ADDENDA: 01

Moore Station Expansion

Project Name: Moore Station Expansion Addendum 01
Addendum Date: August 8, 2022

A511

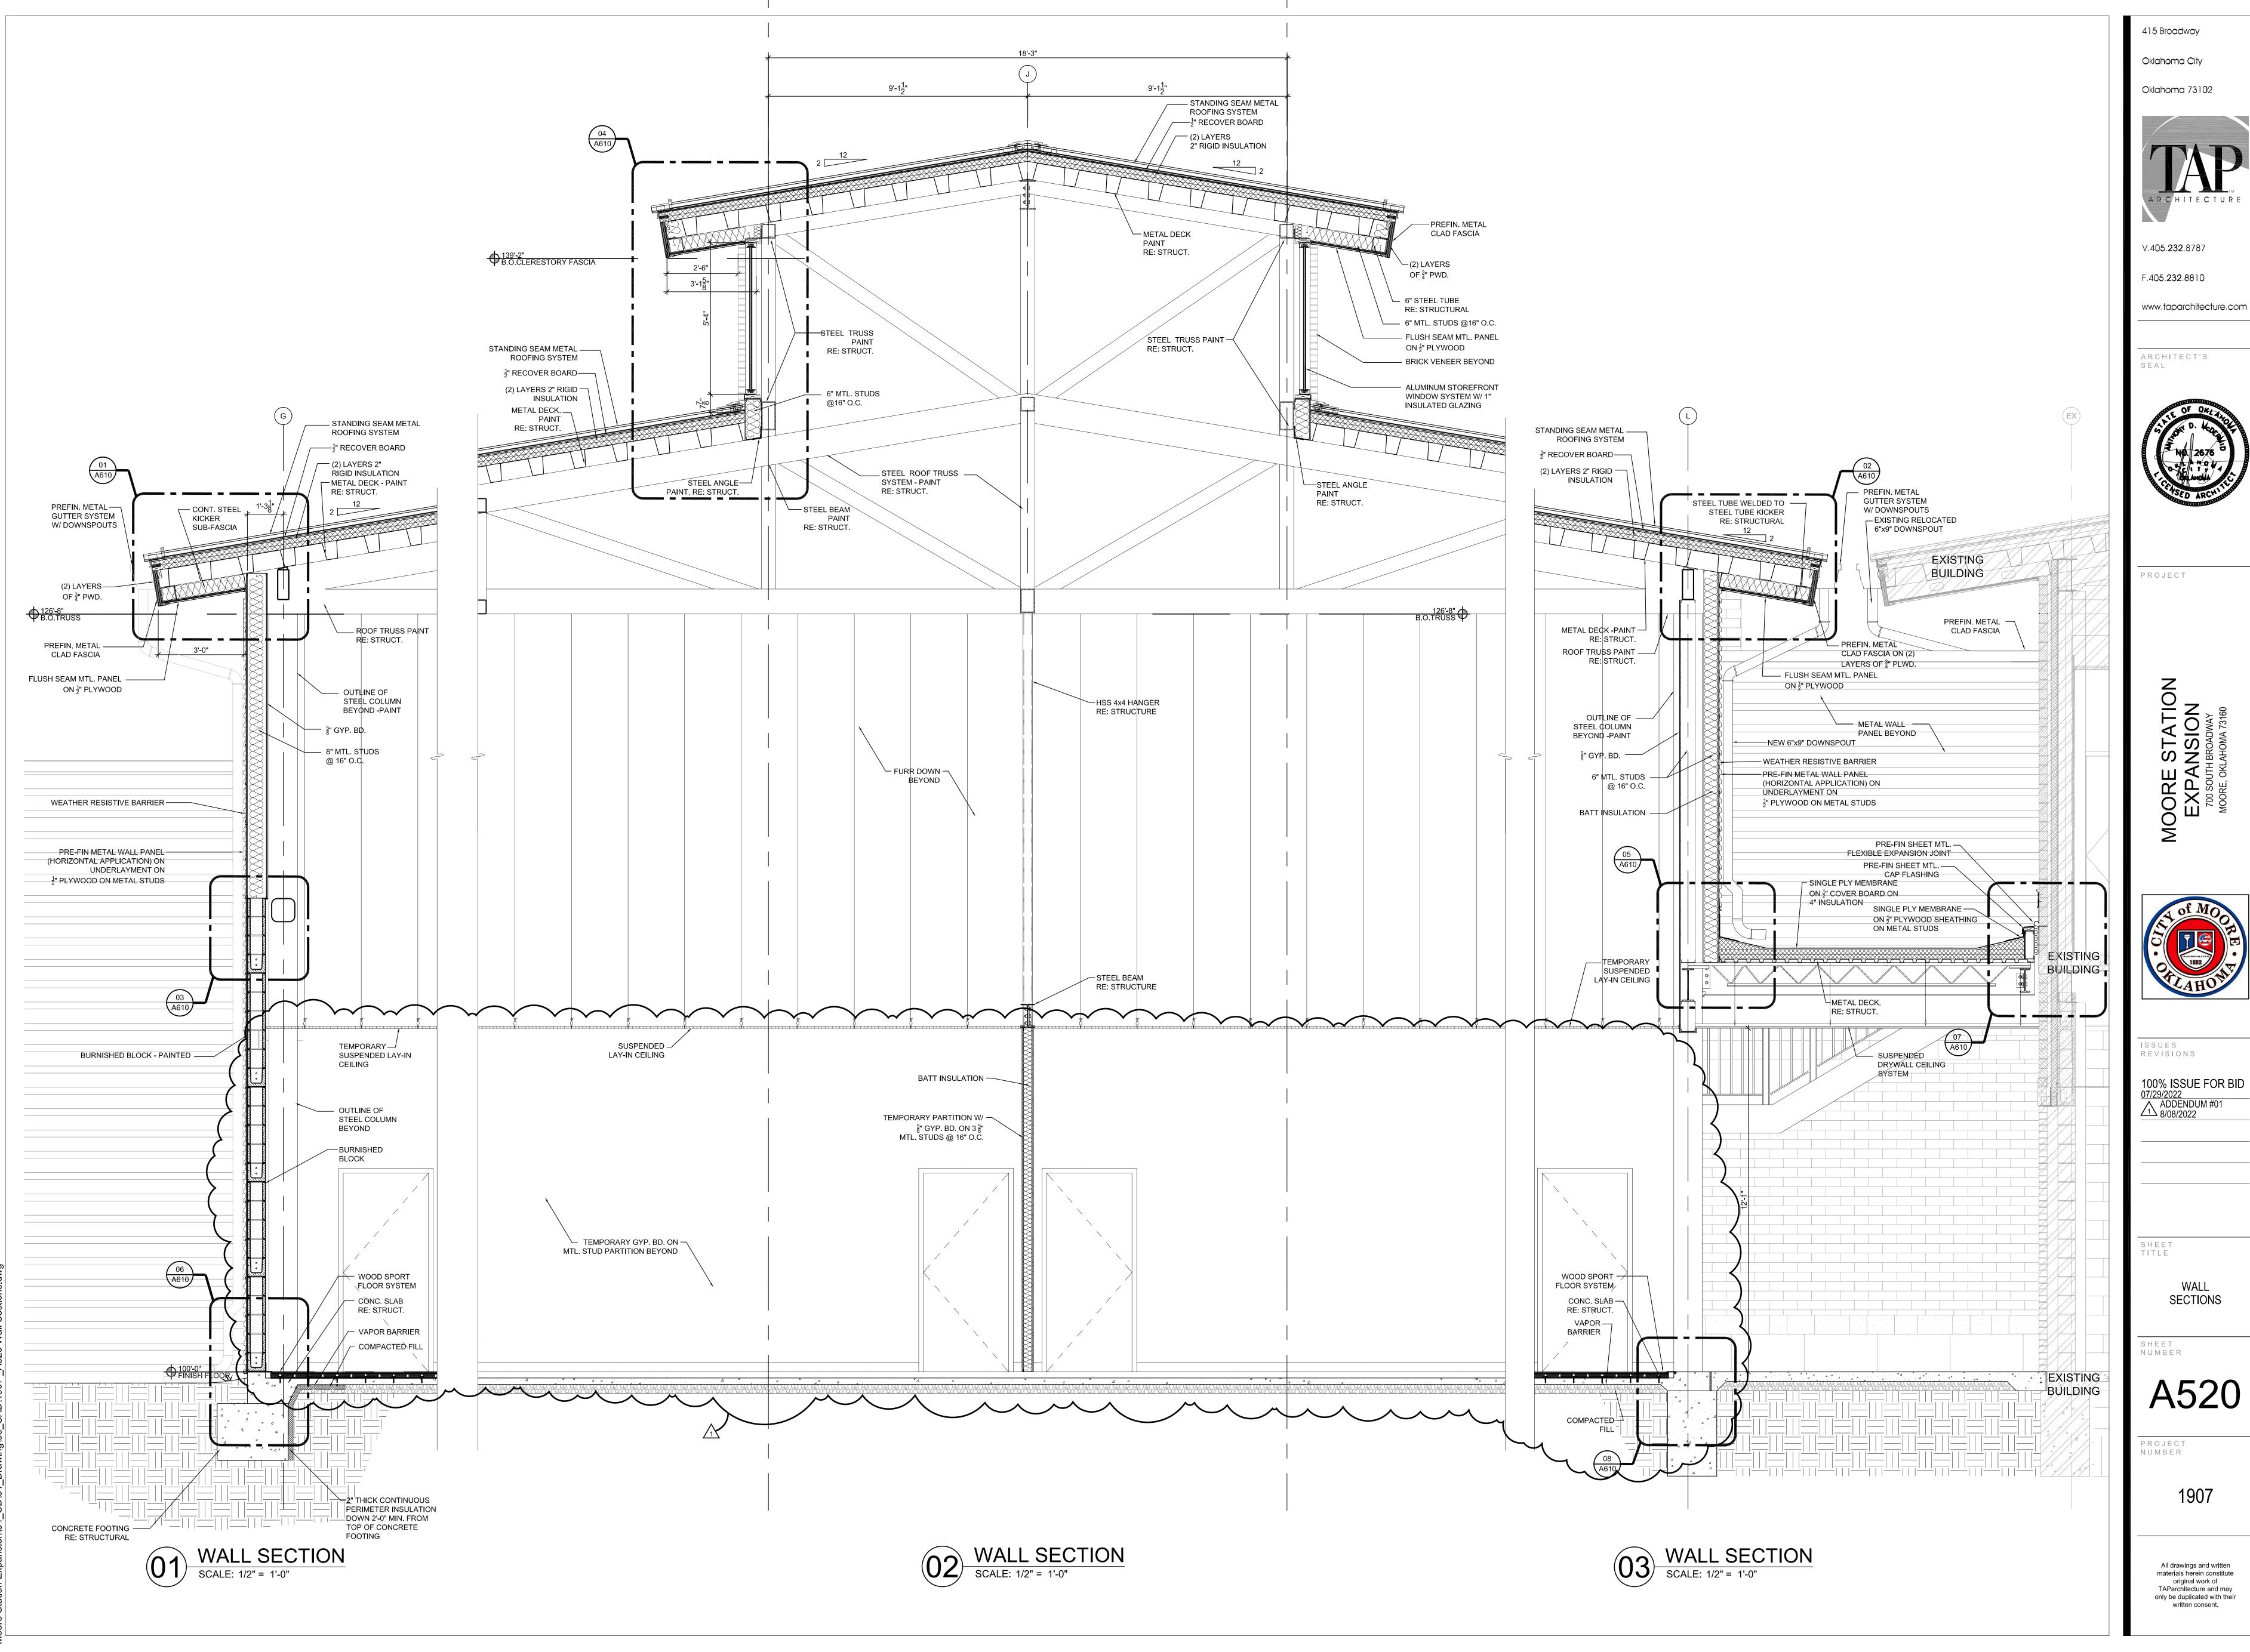
A1.6.11: Refer to Sheet A511 – Add temporary partition of 5/8" Gyp.

Board on 3 5/8" metal studs @ 16" O.C.

A530

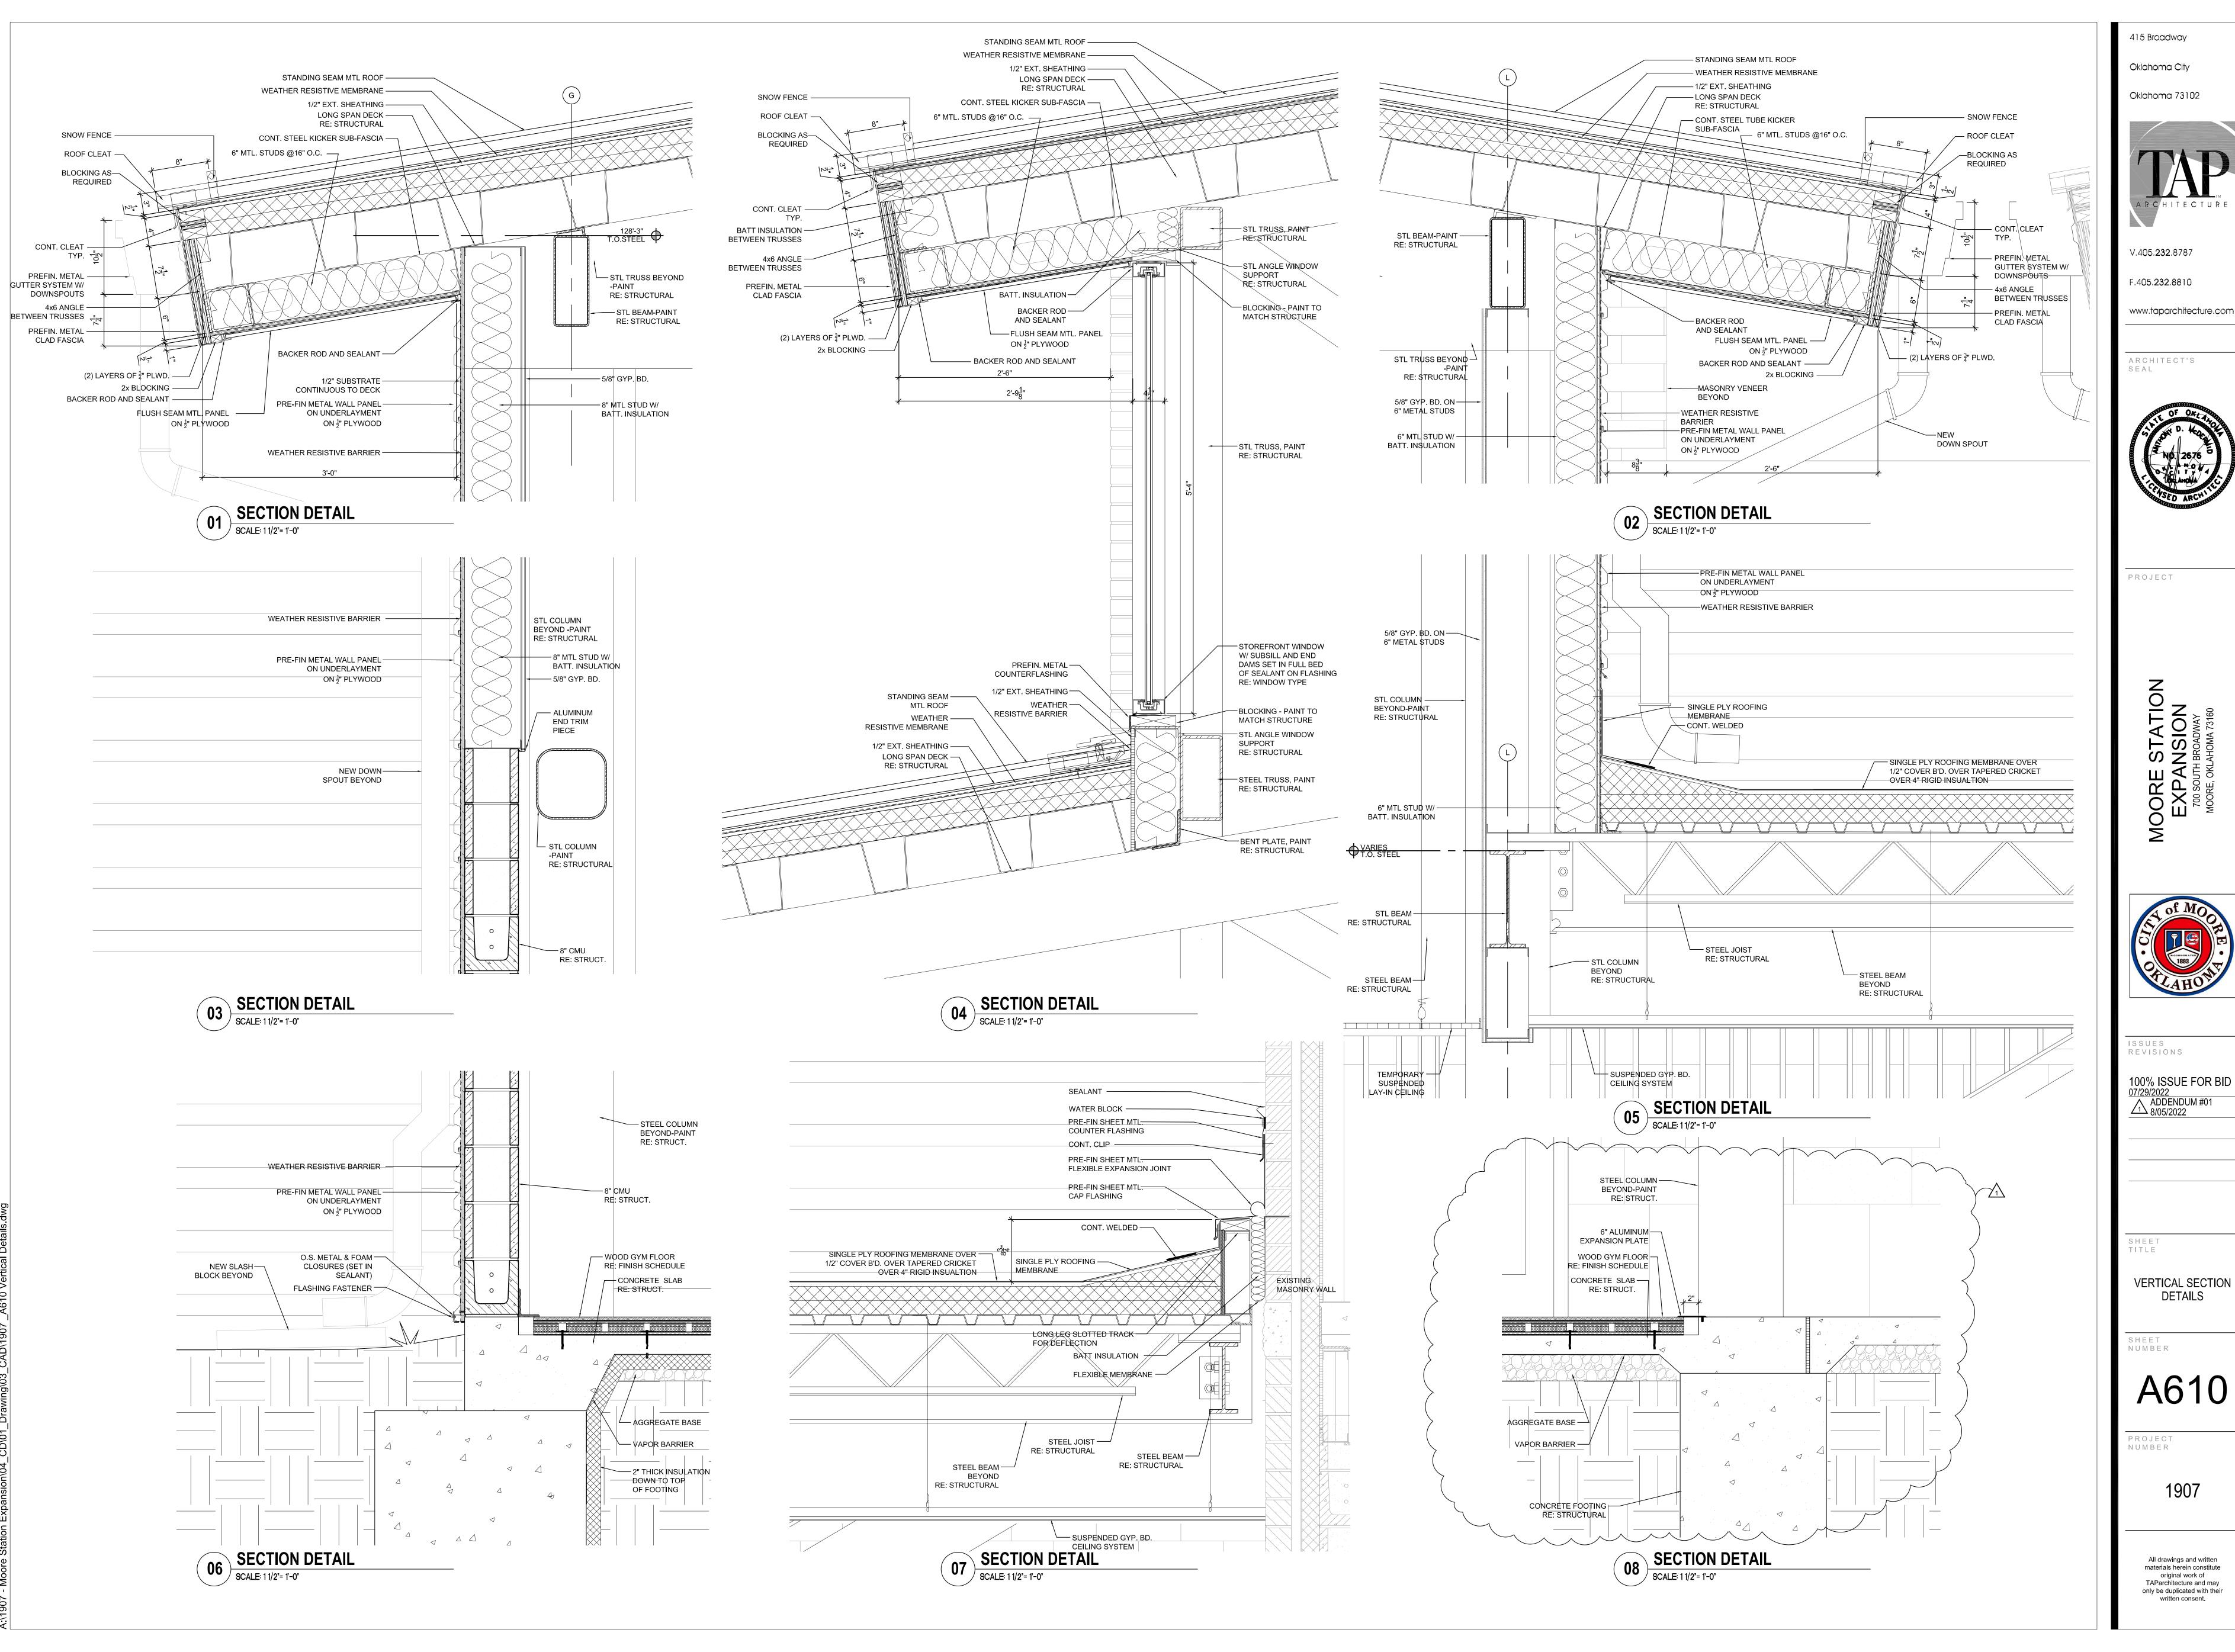
A1.6.13: Refer to Sheet A530 – Revised dimensions and column location

for stairs.

E301

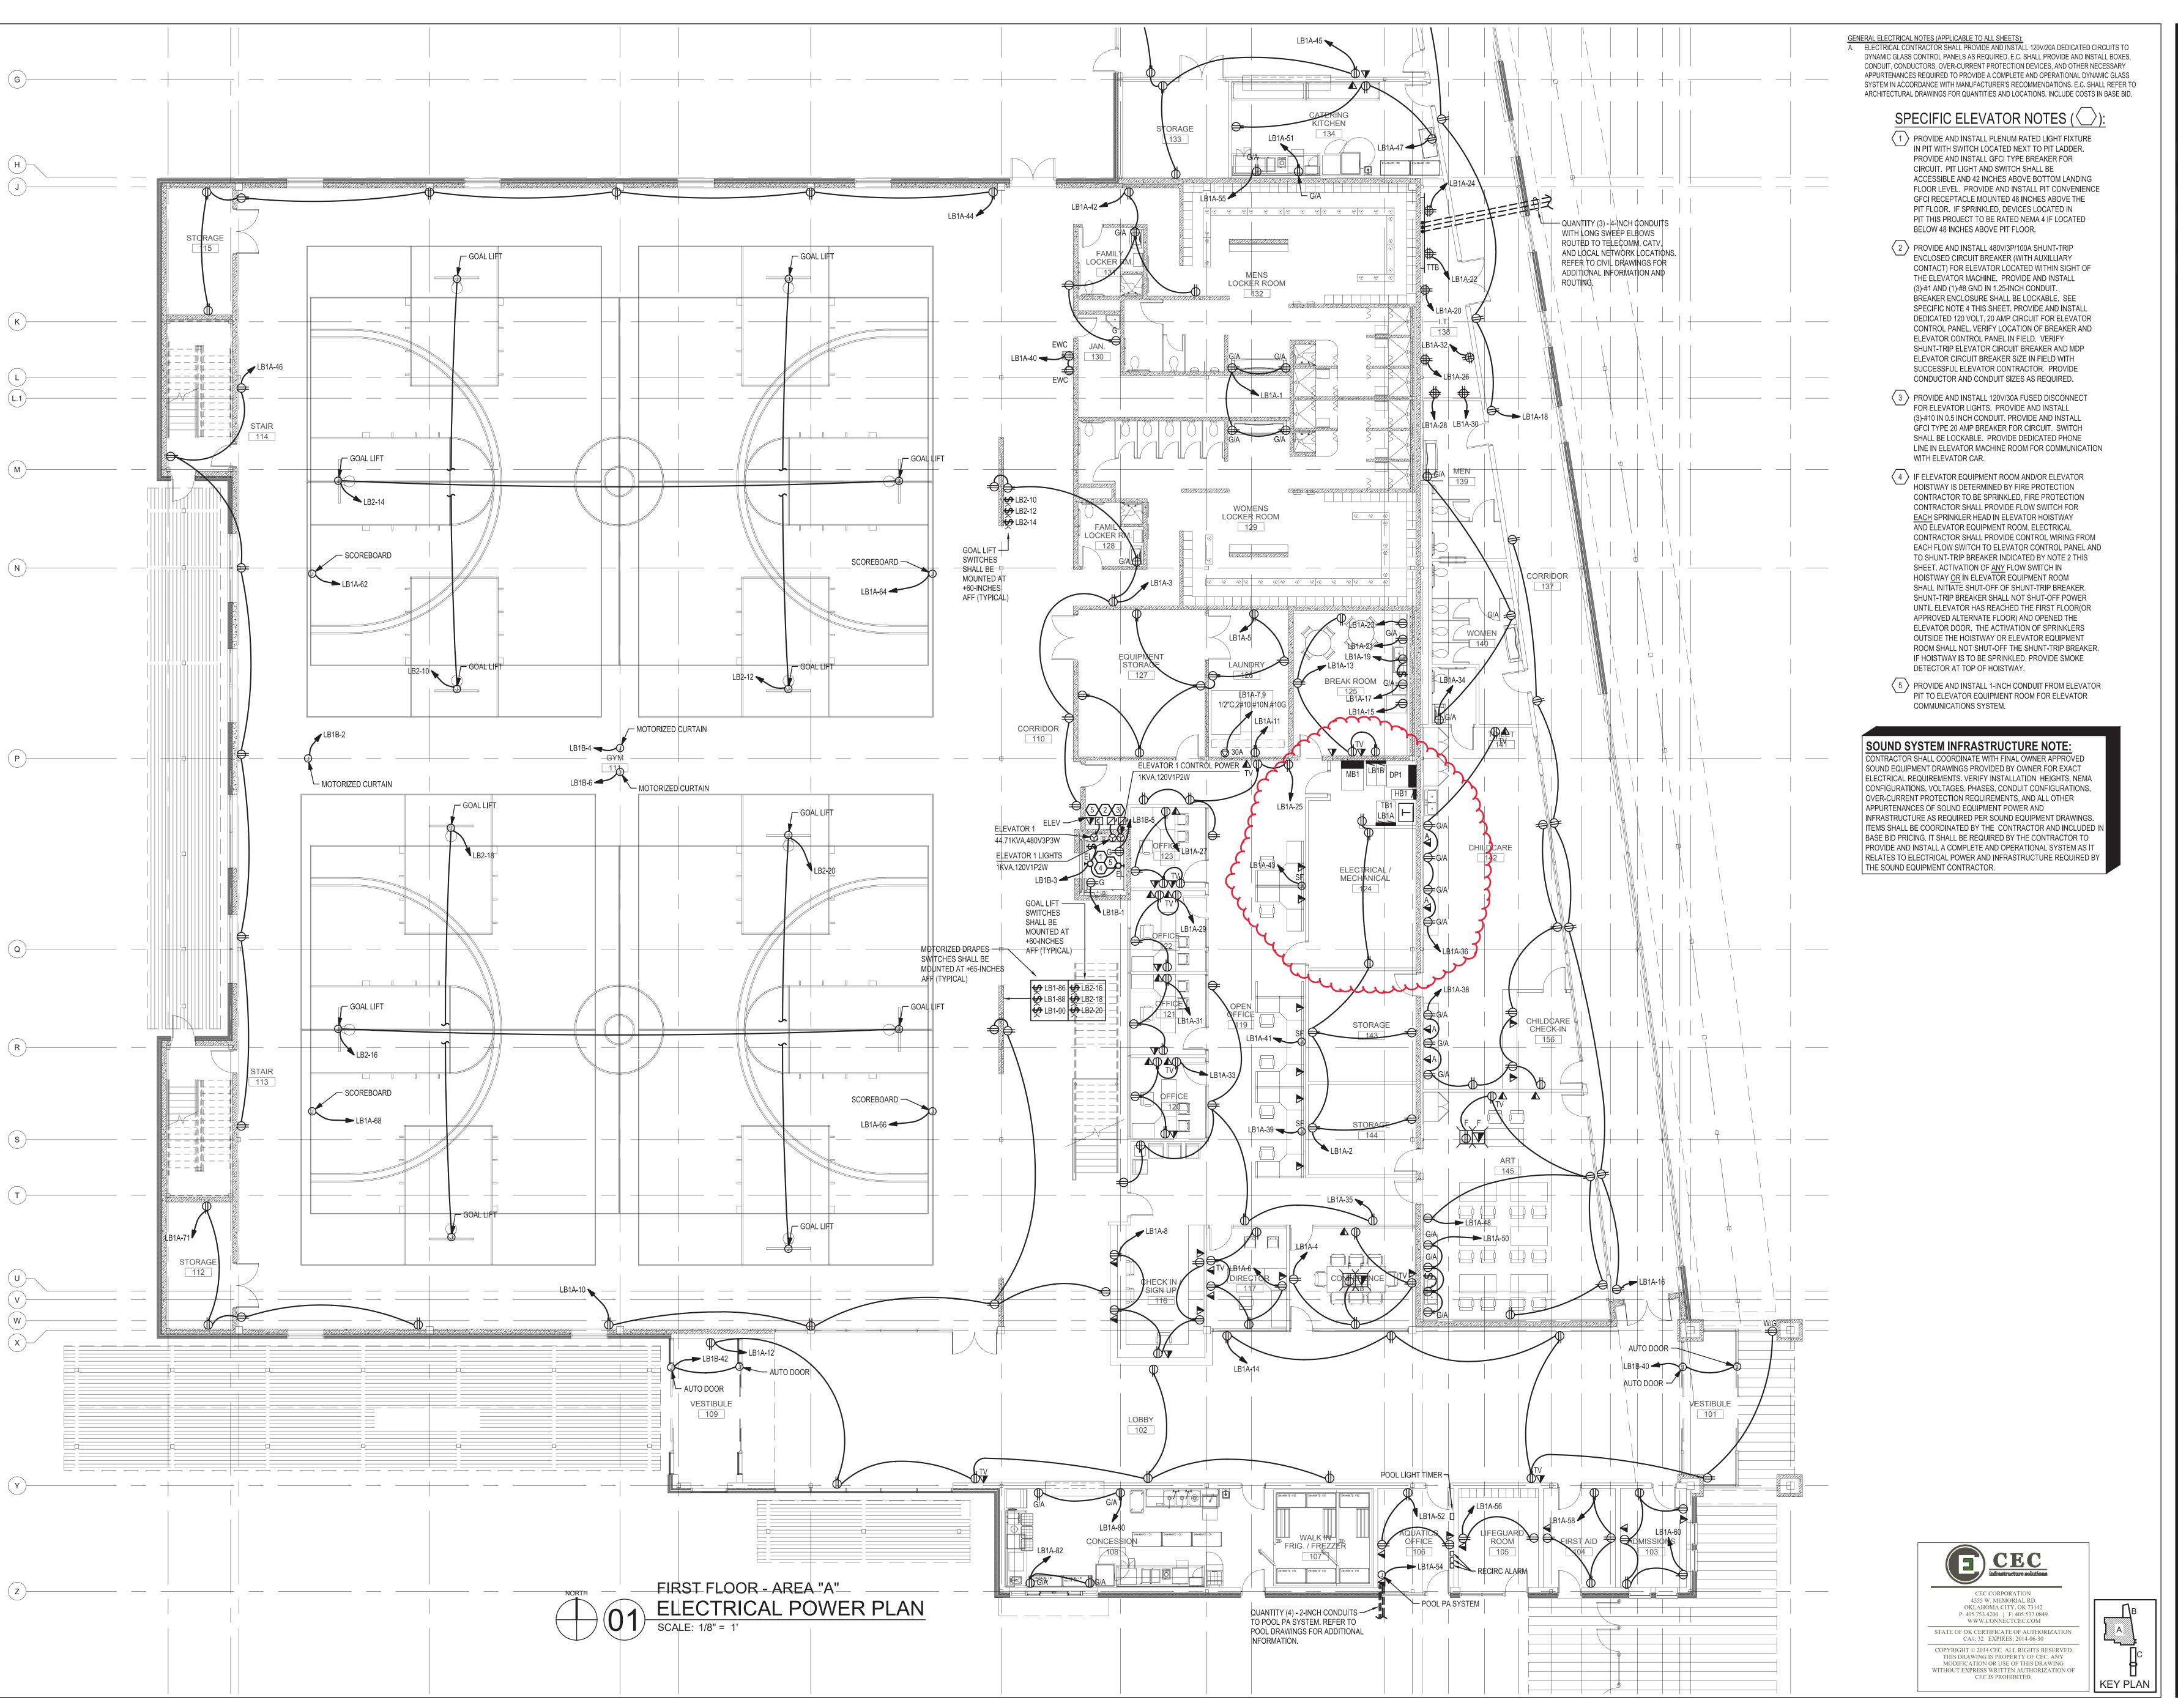
Question 2) Refer Sheet E301: For accurate bidding purpose, We need this location and distance to the main electrical. **Answer**: Existing Building Sheet E301 attached. Field verify Dimensions as per existing drawings.
